UNITED STATES PATENT AND TRADEMARK OFFICE

10/765,391

Office Action Summary	Application No. 10/765,391	Applicant(s) DI BITONTO ET AL.	
	Examiner PHONG H. NGUYEN	Art Unit 3724

DETAILED ACTION

FIG. 5

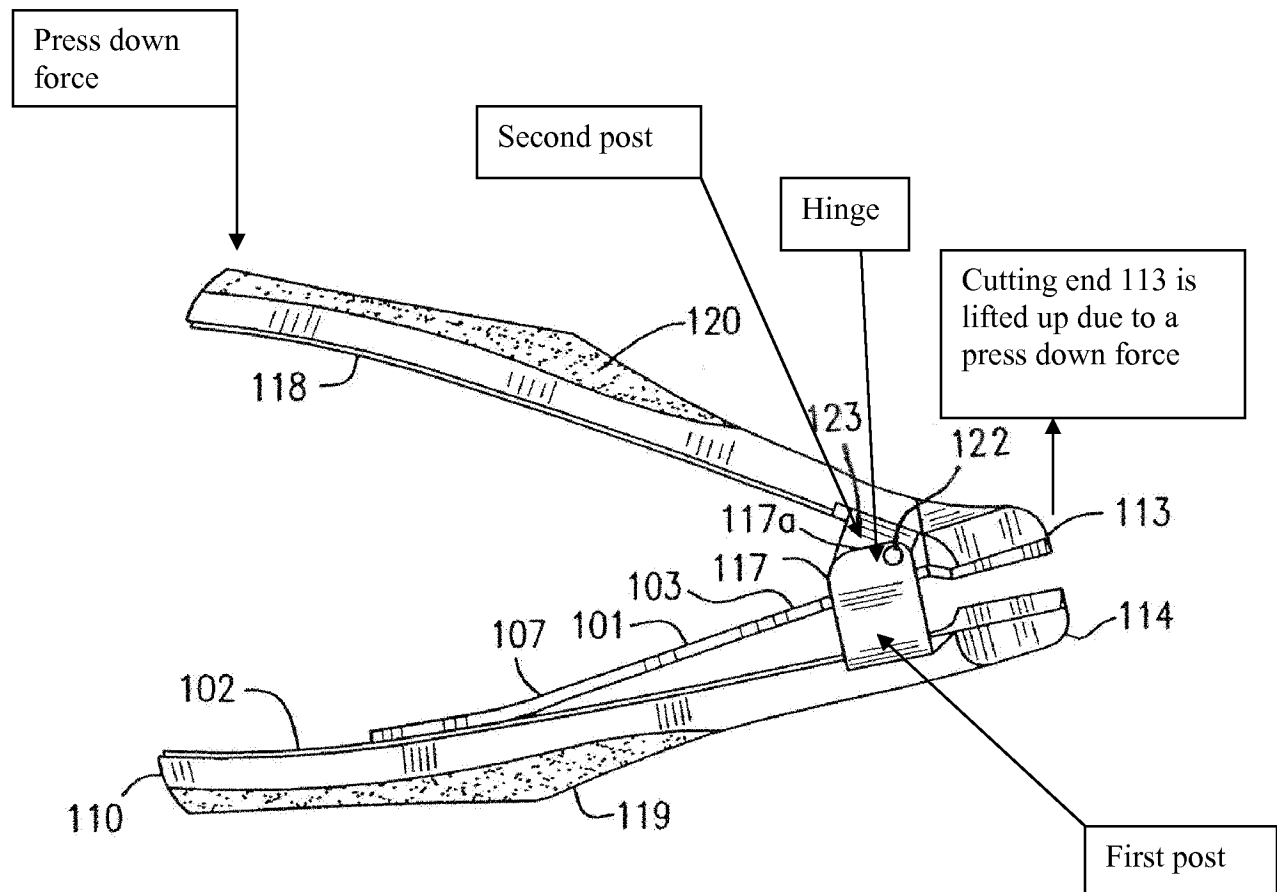
2. The disclosure is objected to under 37 CFR 1.71, as failing to describe how the claimed nail clipper functions. It is to be noted that for the purpose of this office action, the Examiner uses the latest Amendments to the Specification and the Drawings filed on 12/15/2008 to explain his position.

It is to be noted that the last sentence in the Amendments to the Specification states “a second post 122 is connected to the post 117 by a hinge 123” while the Amendments to Drawings show the second post being designated by numeral 123 and the hinge being designated by numeral 122. For the discussion, the Examiner assumes that numeral 123 is the second post and numeral 122 is the hinge.

According to the principle of leverage, the first post 117 acts as a fulcrum and the lever 118 pivots about the hinge 122. When the lever 118 is pressed down, the cutting end 113 is lifted up according to the principle of leverage. This is not the intended use of the nail clipper since the press down force is supposed to bring the cutting ends (113, 114) close together to cut a nail.

Applicant is required to submit an amendment which clarifies the disclosure so that the examiner may make a proper comparison of the invention with the prior art. Applicant should be careful not to introduce any new matter into the disclosure (i.e., matter which is not supported by the disclosure as originally filed).

The Applicant argues that the lever 118 and the cutting end 113 are not connected because the connection between the lever 118 and the cutting end 113 is shown as a break line in the reproduced Fig. 5 in the Remark. This argument is not persuasive. The break line may show the change in shape of the lever 118 and the cutting end due to the cutting end being bended to a side but not in front of the clipper. If the lever 118 and the cutting end are not connected as argued by the Applicant, then how can the cutting end 113 be spaced apart from the cutting end 114? Furthermore, the reproduced Fig. 5 does not explain how the lever 118 presses or moves the cutting end 113 toward the cutting end 114.
